IEEE Std 80™-2000(Revision of
IEEE Std 80-1986)

Errata to IEEE Guide for Safety in AC Substation Grounding

IEEE Power Engineering Society*Correction Sheet***Issued 21 February 2007**

Figure 12—Basic shock situations

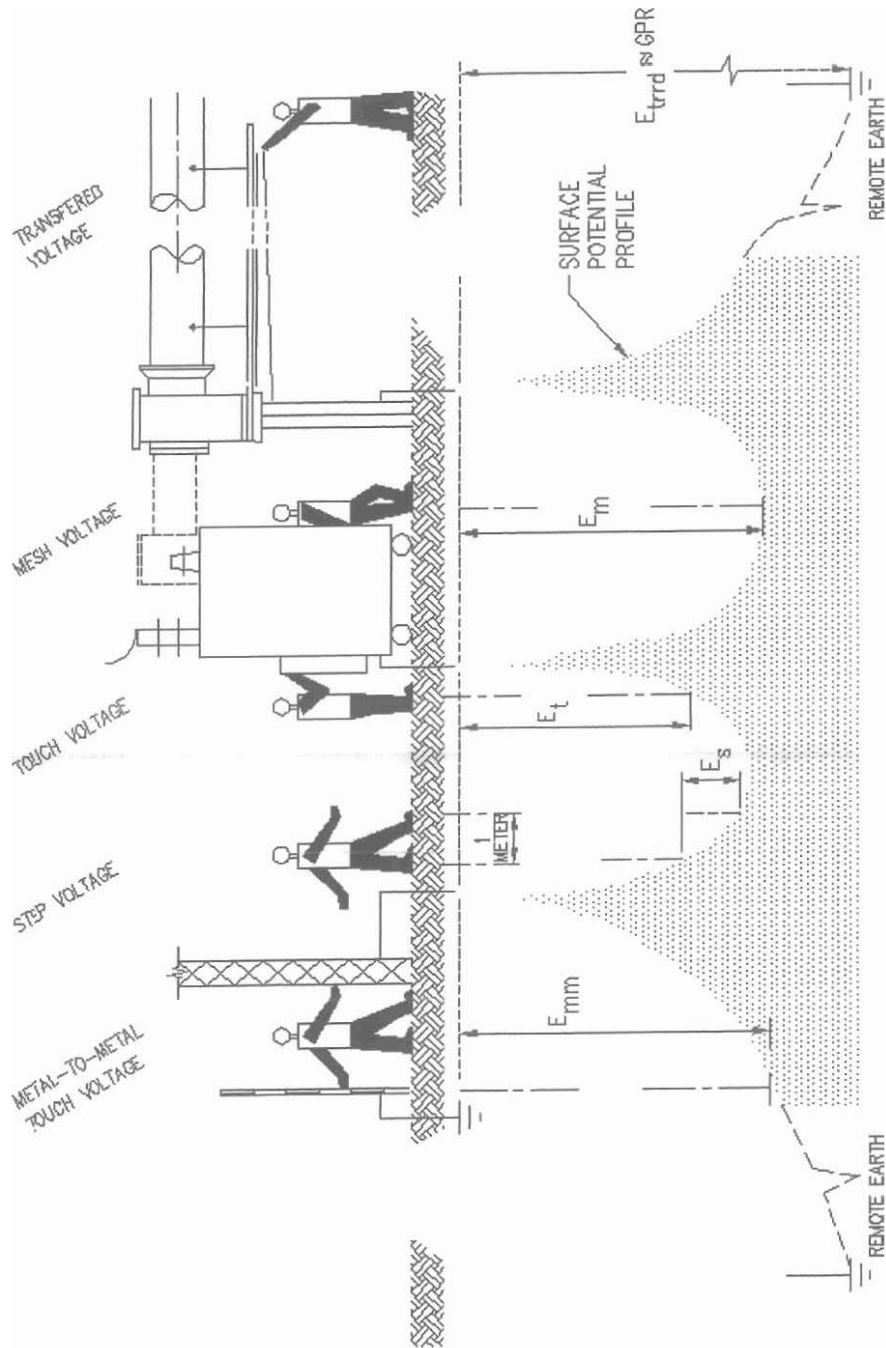
Page 24, Figure 12—Basic shock situations, should be replaced with the following figure:
